## SUBMISSION TO THE PYRMONT PENINSULA SUB-PRECINCT MASTER PLANS

Thank you for providing the opportunity to make a submission on the draft Pyrmont Peninsula Sub-Precinct Master Plans and accompanying documents. This submission has been prepared by Ethos Urban on behalf of The Star Entertainment Group Limited (The Star).

**Figure 3 The Star Wind Recommendations**

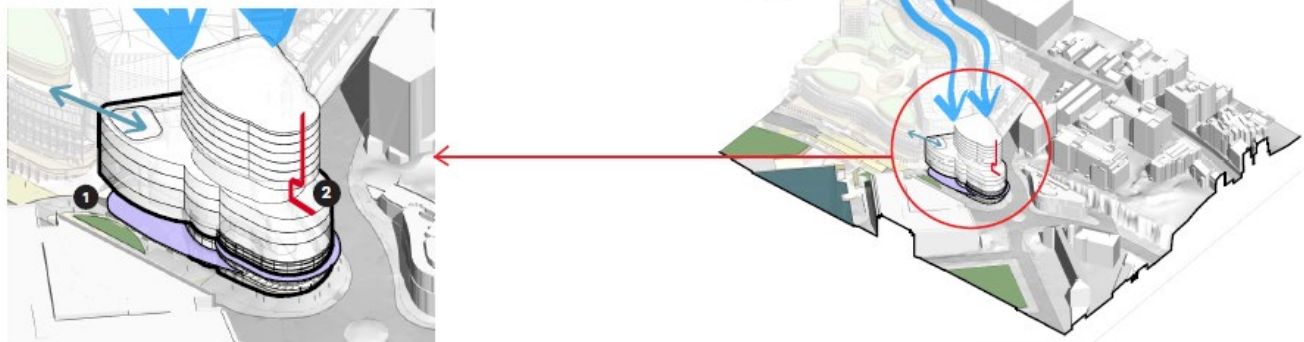
Wind advice informed the development of The Star Key Site Master Plan. It was recommended a future built form on the site include two (2) awnings at differing heights and a tower setback of a minimum 6-7m at the northern most portion of the tower (see **Figure 3**).

It is recommended DPE review their setback controls assigned for the North Site and consider the significant impact they will have on future floor plates. Detailed plans showing appropriate setbacks for the North Site which have been informed by wind advice are provided at **Attachment B**. It is noted that broadly, these setbacks and resultant wind conditions were not matters for contention in the Mod 13 submission by the Star. There is therefore no reason to maintain the setback conditions as proposed in the Draft DPE documents exhibited.
